SUBJECT: **ADDENDUM NO. 2 TO CONTRACT DOCUMENTS FOR
INTERSECTION IMPROVEMENTS – ROUTE 123 AT RATHBUN-
WILLARD DRIVE & BLACK OAK DRIVE
ATTLEBORO, MA**

DATE: January 24, 2022

I. ADDENDUM NO. 2

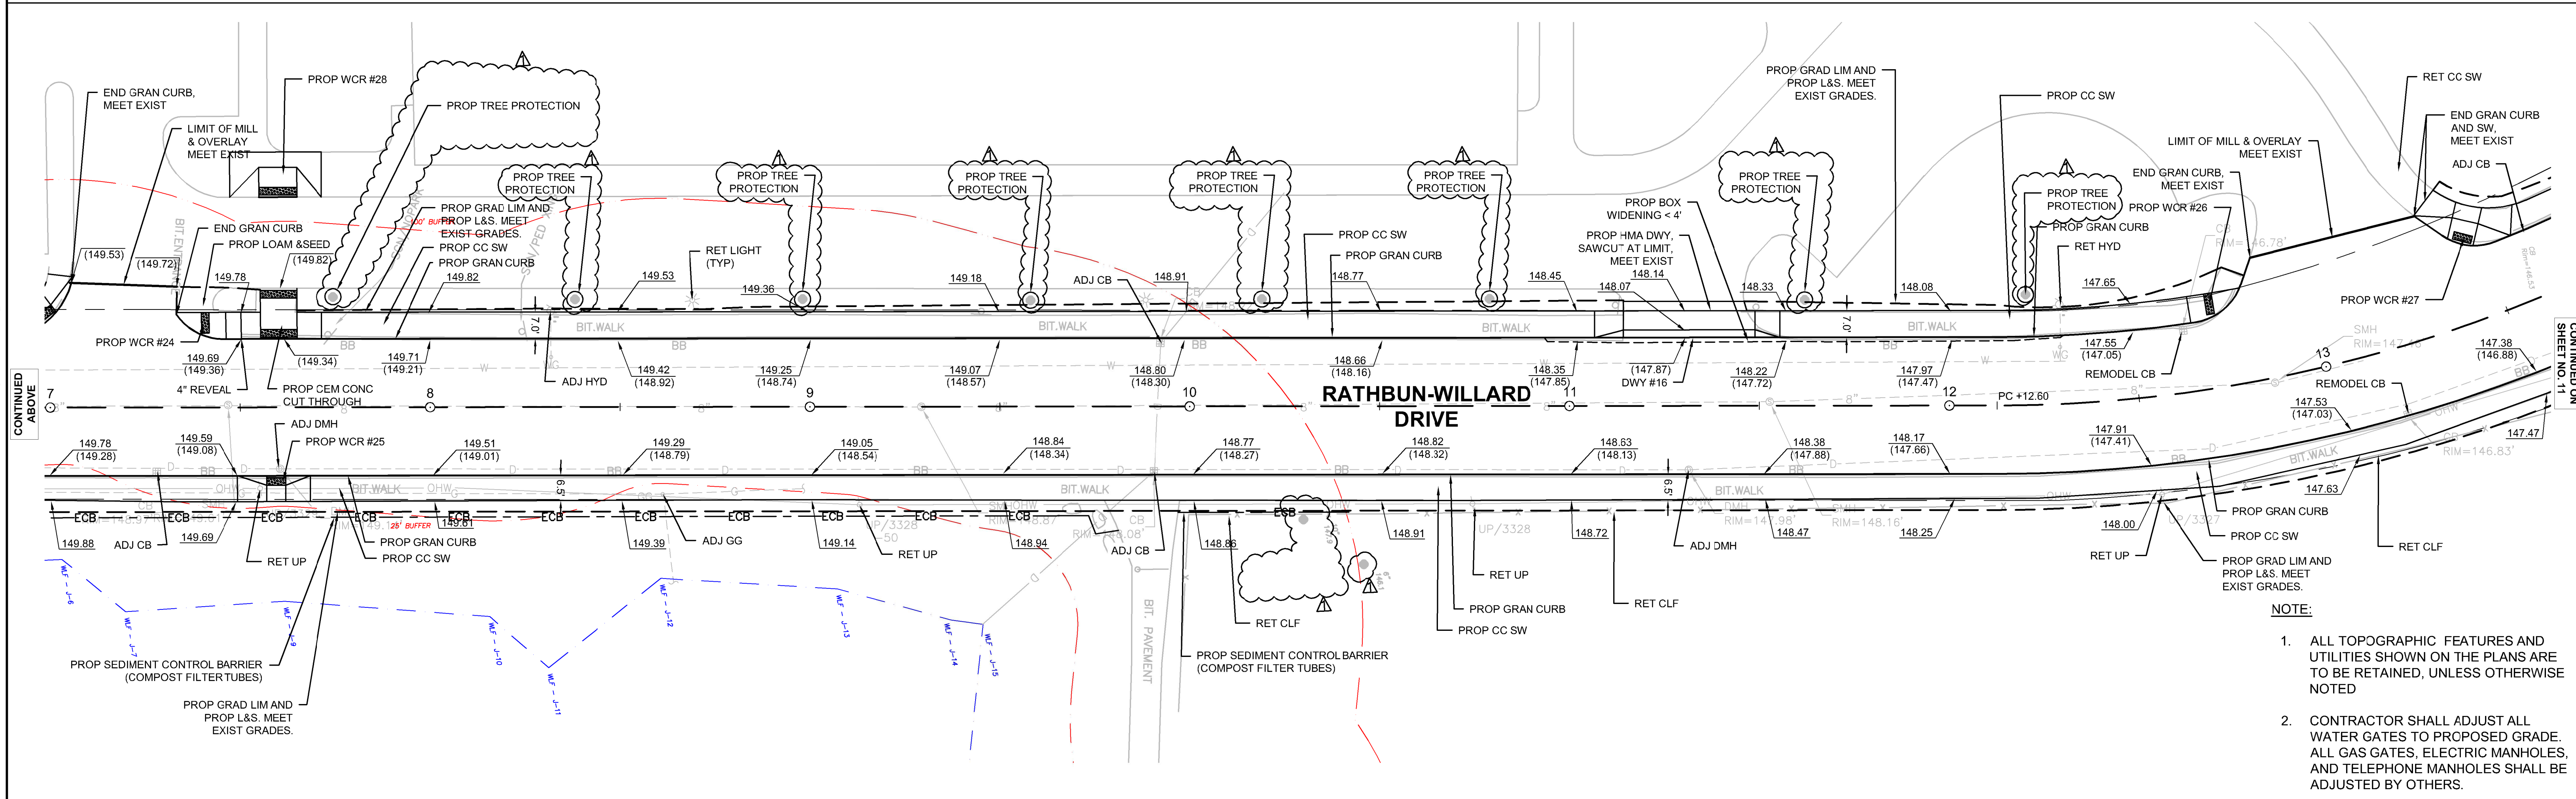
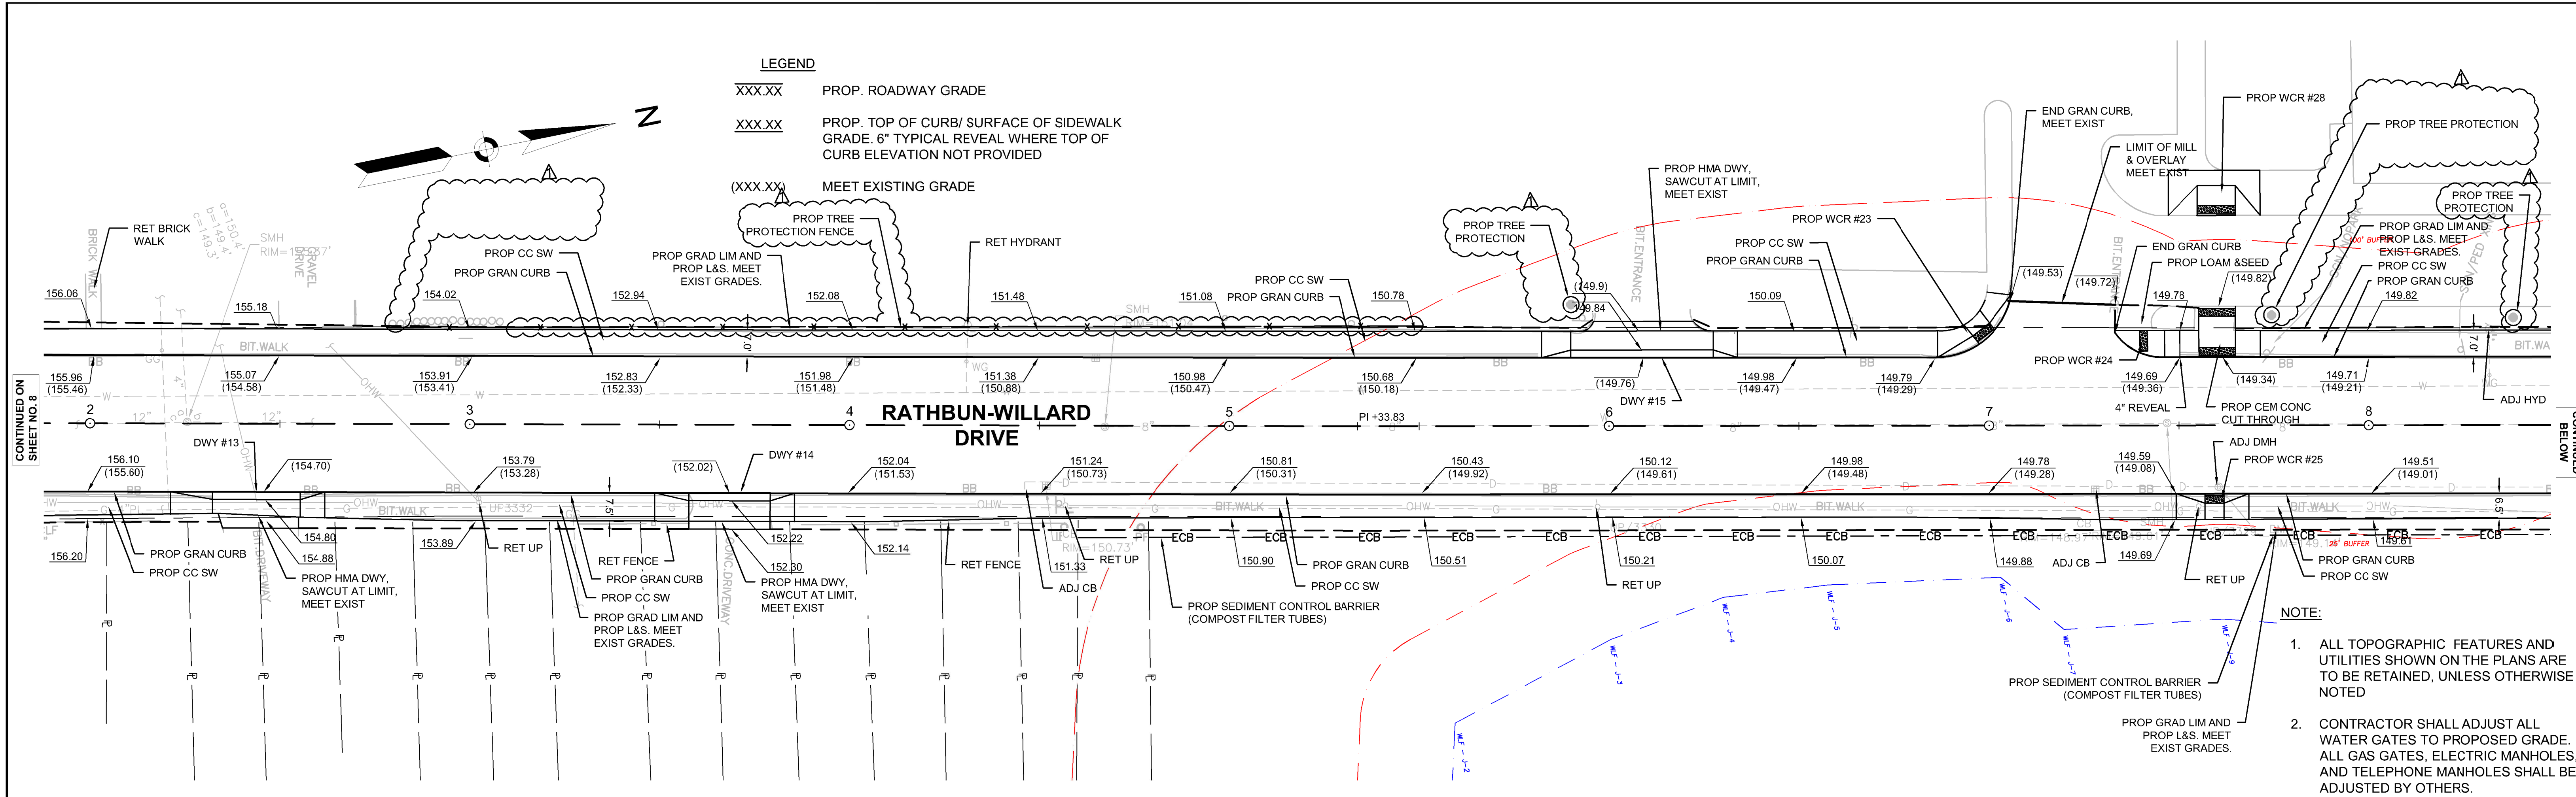
DRAWN BY: KLJMC				REGISTERED PROFESSIONAL		PREPARED BY: BETA		SUBCONSULTANT		SCALE: 20 0 20 40 SCALE IN FEET: 1"=20'		TITLE: Intersection Improvements Route 123 At Rathbun Willard Drive And Black Oak Drive Attleboro, Massachusetts GENERAL PLAN		BETA JOB NO. 7157	
DESIGNED BY: KLJMC														ISSUE DATE: 11/10/2021	
CHECKED BY: DJ														SHEET NO. 8 of 28	
1/21/22 NO CR ADDED TREE PROTECTION AND REVISED SLOPE LIMITS															
NUMBER DATE MADE BY CHECKED BY

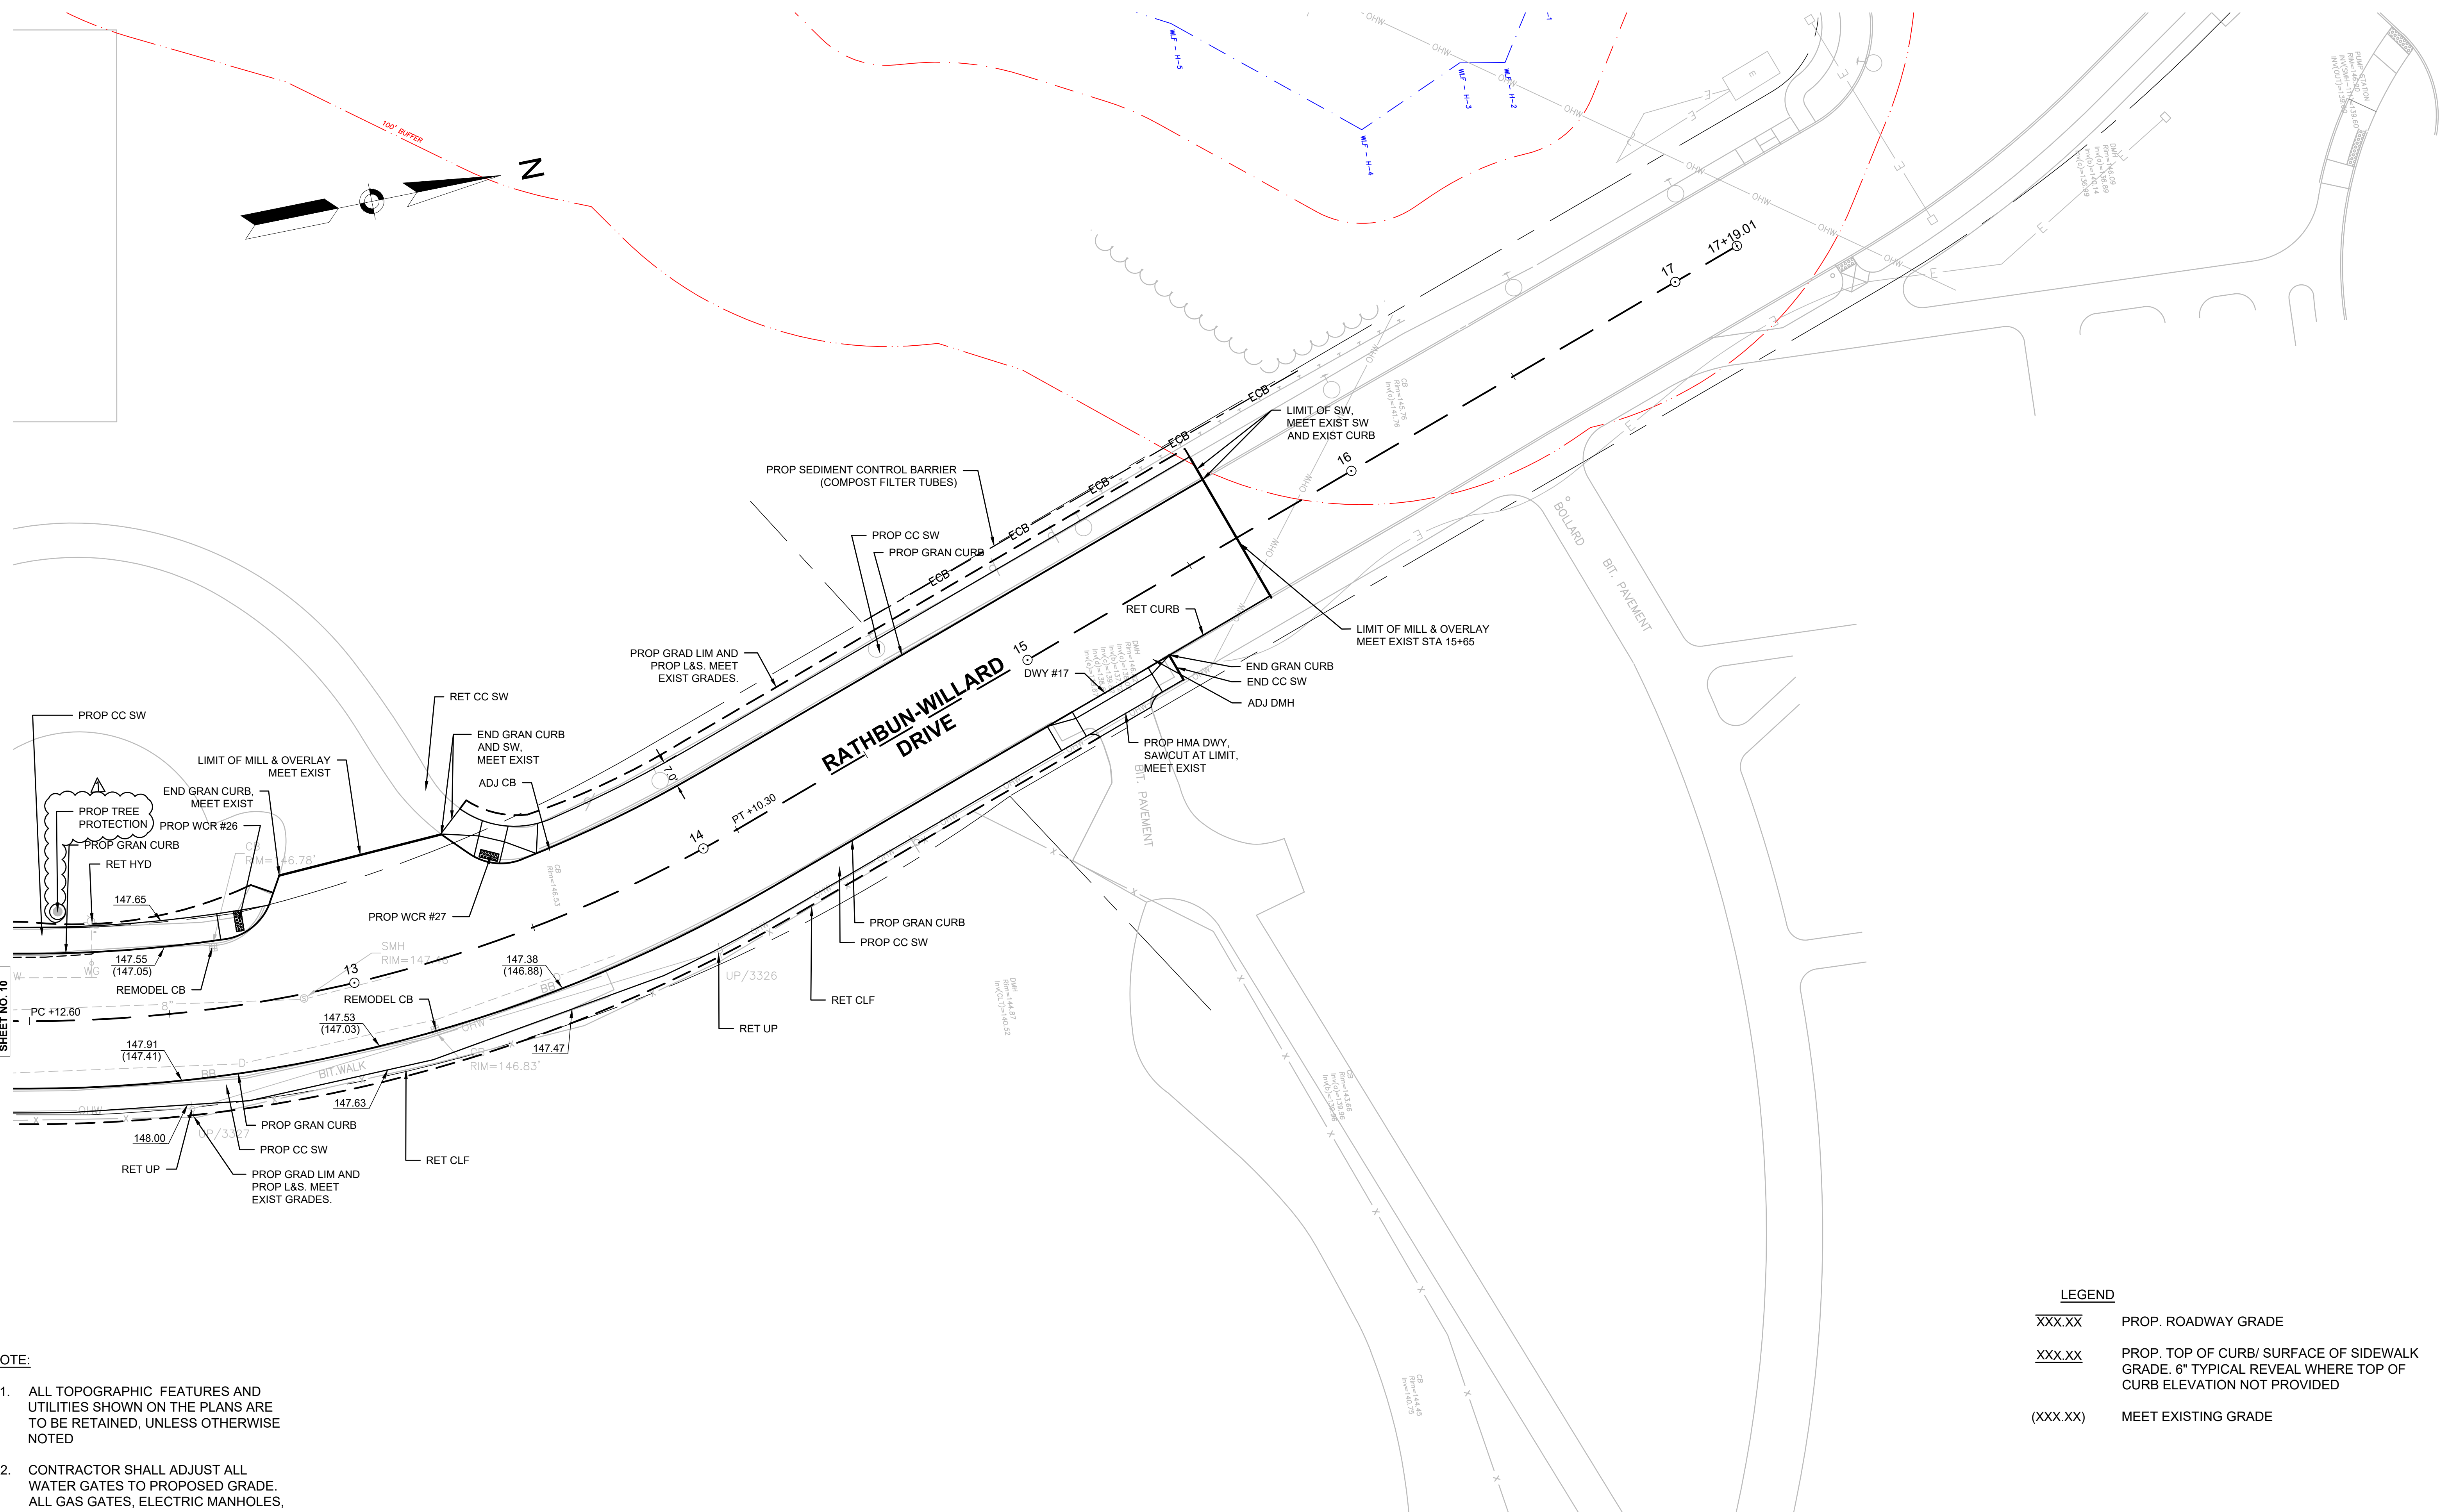
DRAWN BY: KL/JMC		<div>REGISTERED PROFESSIONAL</div> <div></div> <div>www.BETA-Inc.com</div>	SUBCONSULTANT		<div>SCALE</div> <div></div> <div>SCALE IN FEET: 1"=20'</div> <div>UNLESS OTHERWISE NOTED OR CHANGED BY REPRODUCTION</div>		<div>TITLE</div> <div>Intersection Improvements Route 123 At Rathbun Willard Drive And Black Oak Drive Attleboro, Massachusetts GENERAL PLAN</div>		BETA JOB NO. 7157	
				DESIGNED BY: KL/JMC			ISSUE DATE 11/10/2021							
				CHECKED BY: DJ			SHEET NO. 10 of 28							
<div><div></div><div>1/21/22</div><div>NO</div><div>CR</div><div>ADDED TREE PROTECTION</div></div>														
NUMBER		DATE		MADE BY		CHECKED BY		REVISIONS
